Access Compliance Report Public Rights-of-Way (Curb Ramps)

Main Street: SILVER_FOX_RD Cross Street: MAINWAY_DR Location: SW

ADA ID: RPRK211208125749 Ramp Type: Type 1 - Perpendicular Diagonal Initial Pass/Fail: Fail Overall Compliance: No Severity Score: 2

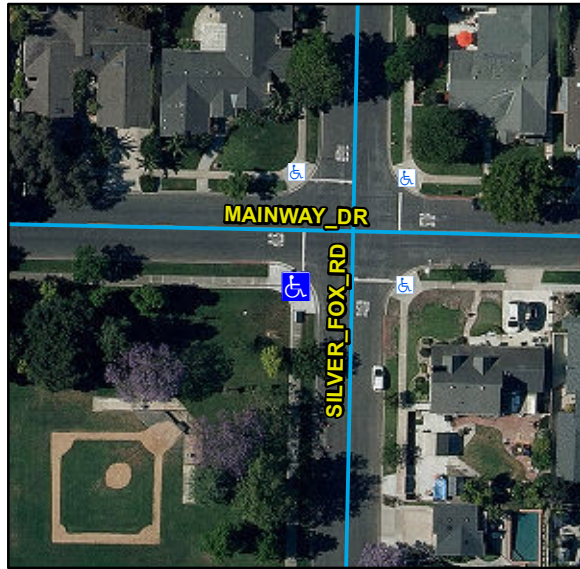
Compliance	Description	Data	Compliance	Description	Data
N/A	Ramp Length (in)	84	N/A	Flare Type LT	
Yes	Ramp Width (in)	48			N/A
Yes	Ramp Run Slope (%)	4.8	N/A	Flare Slope LT (%)	N/A
No	Ramp Cross Slope (%)	2.3	N/A	Flare Traversable LT	N/A
N/A	Landing Present	N/A	N/A	Flare Type RT	
N/A	Landing Length (in)	N/A			N/A
N/A	Landing Width (in)	N/A	N/A	Flare Slope RT (%)	N/A
N/A	Landing Run Slope (%)	N/A	N/A	Flare Traversable RT	N/A
N/A	Landing Cross Slope (%)	N/A	N/A	DWS Provided	N/A
N/A	Landing Movement Obstructed?	N/A	N/A	DWS Contrast	N/A
	Landing Movement Type	N/A	N/A	DWS Length (in)	N/A
N/A	Landing Shared	N/A	N/A	DWS Full Width	N/A
N/A	Clear Space	Yes	N/A	DWS Offset Left (in)	N/A
N/A	Clear Space To Crosswalk (in)	N/A	N/A	DWS Offset Right (in)	N/A
N/A	Marked Crosswalk 1	No	N/A	Marked Crosswalk 2	No
	Crossing 1 Direction	E		Crossing 2 Direction	N
	Marked Crosswalk 1 Width (in)	N/A		Marked Crosswalk 2 Width (in)	N/A

N/A	Ramp Inside Crosswalk 1	N/A	Yes	Ramp Inside Crosswalk 2	N/A
	Crossing 1 Slope (%)	8.7		Crossing 2 Slope (%)	4.2
	Crossing 1 Cross Slope (%)	1.8		Crossing 2 Cross Slope (%)	1.4
N/A	Gutter Ponding	N/A	N/A	Curb Slope	3.9
Yes	Gutter Lip Height (in)	0		Road Run Slope (%)	1.7
N/A	Gutter Run Slope (%)	N/A		Road Cross Slope (%)	8
N/A	Gutter Cross Slope (%)	N/A			
Yes	Overall Surface Condition: Acceptable		Yes	Perp Joint Present	Yes
	Cross Gutter Present?	No		Spandrel Present?	No
	Replace Cross Gutter?	N/A		Replace Spandrel?	N/A

Remove & Replace Curb Ramp With Two New Directional Ramps or Equivalent.

R304.5.3, STD 1115
